Staff Summary Report

SUBJECT: Hold a public meeting for a Development Plan Review for **CAMPUS SUITES ON THE RAIL** located at 1900 E Apache Boulevard.

DOCUMENT NAME: DRcr_CampusSuites_121307

DPR07208 – Development Plan Review for a site plan, building elevations and landscape plan

Site Plan
 1" = 40'-0"

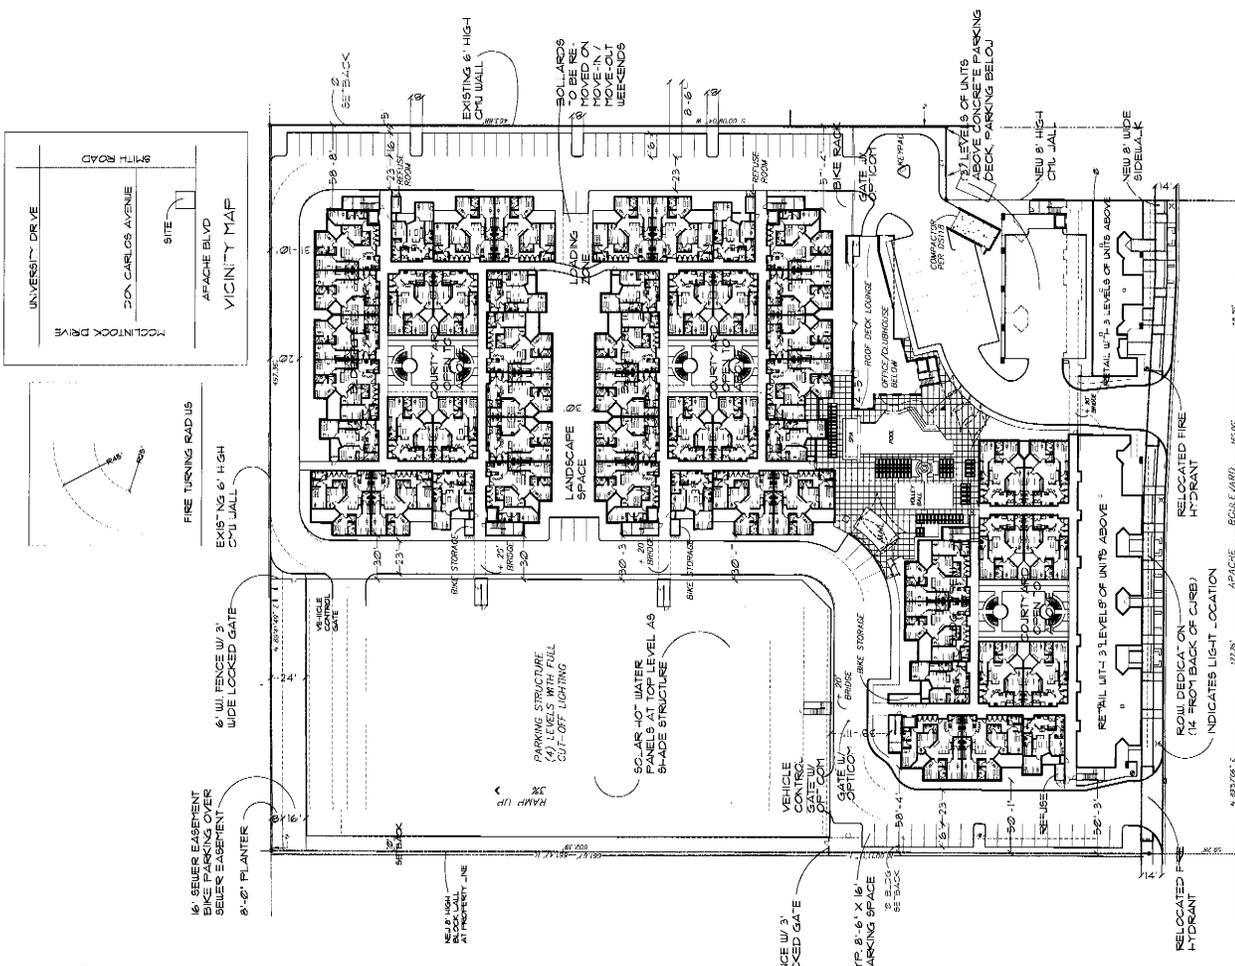
2. Provide 8'-0" wide public sidewalk along arterial roadways, or as required by Traffic Engineering Design Criteria and Standard Details.
3. Provide an 8' perimeter wall on the west, east and north sides of the property.

4. Provide service yard and mechanical yard walls that are at least 8'-0" tall as measured from adjacent grade and are at least the height of the equipment being enclosed, whichever is greater. Verify height of equipment and mounting base to ensure that wall height is adequate to fully screen the equipment. Locate electrical service entrance sections inside the service yard, as indicated.

6. Provide upgraded paving at each driveway apron consisting of unit paving. Extend unit paving in the driveway from the back of the accessible public sidewalk bypass to 20'-0" on site and from curb to curb at the drive edges.

L-1 SHEET 3 OF 3

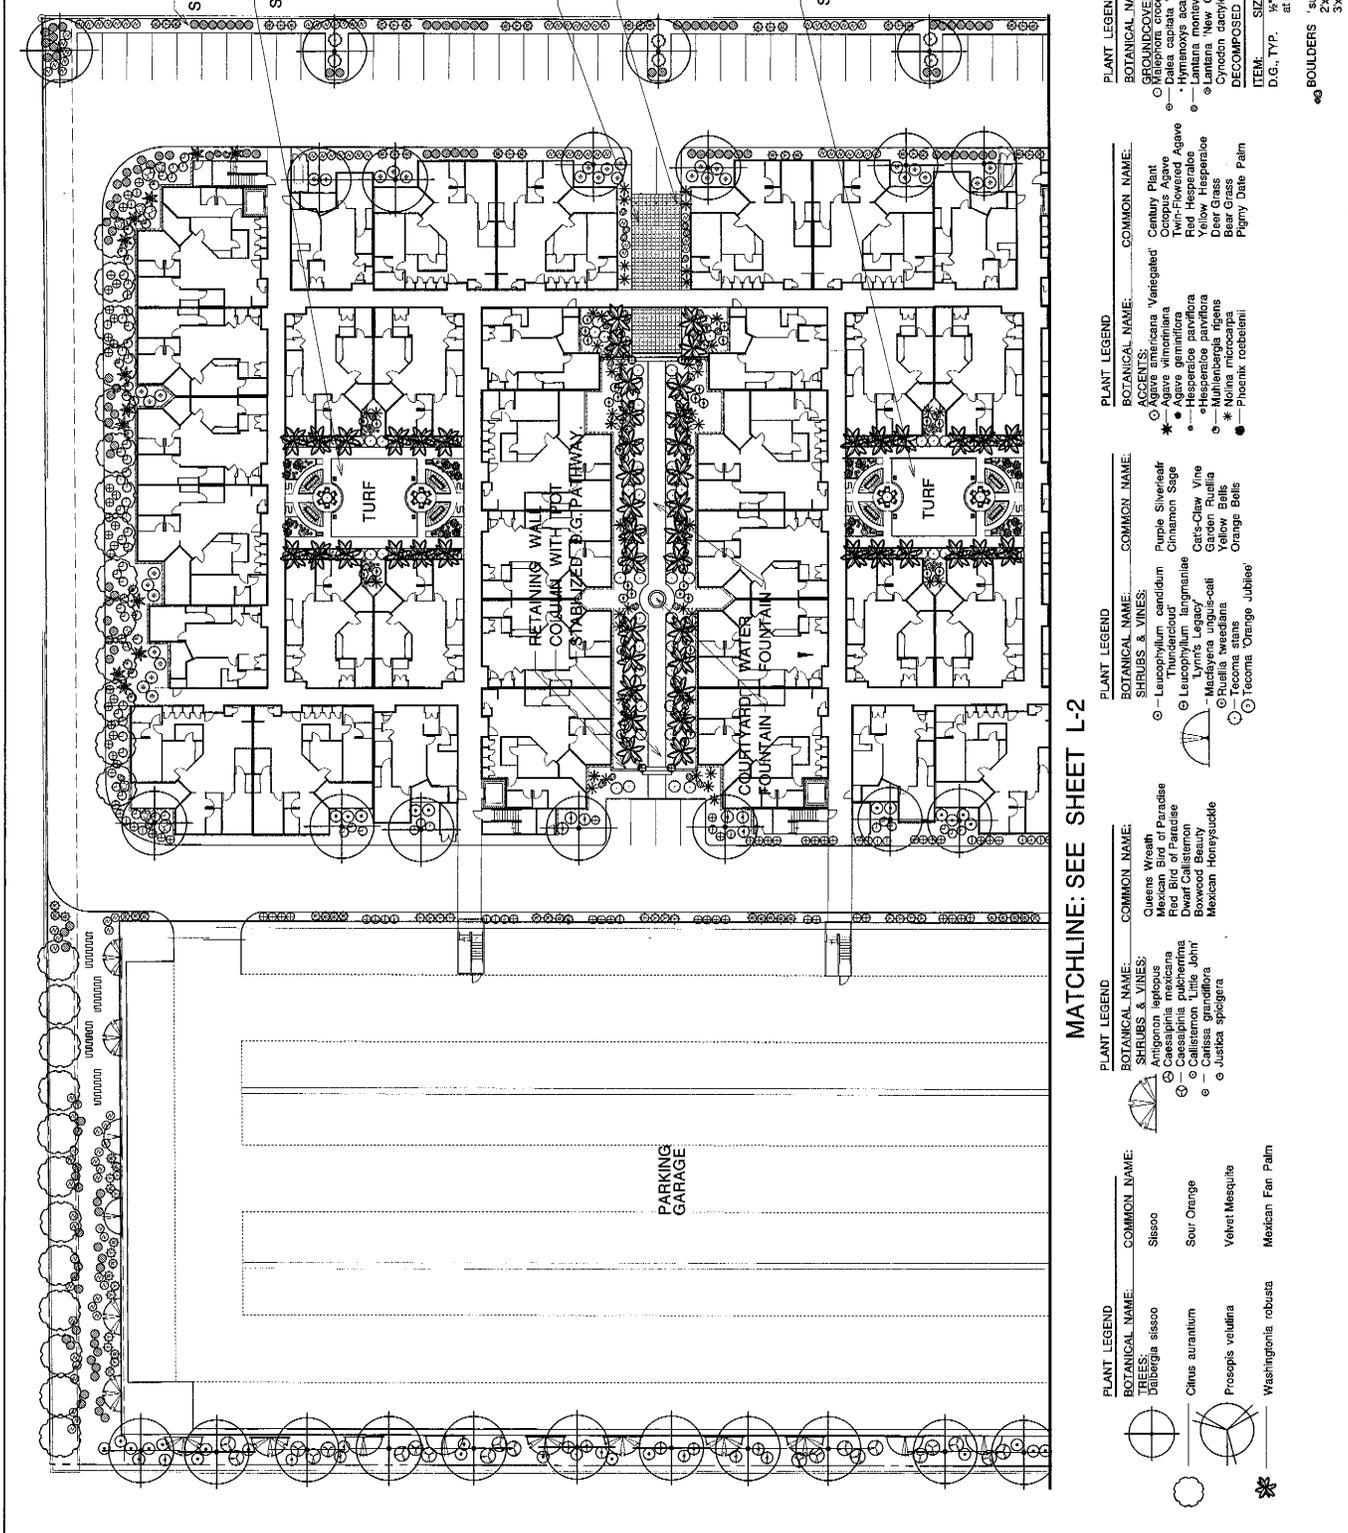
20. Add 5 gallon Ficus pumila: Creeping Fig or other staff approved vine to the east and south face of the parking garage.
21. Irrigation notes:
 - a. Provide dedicated landscape water meter.
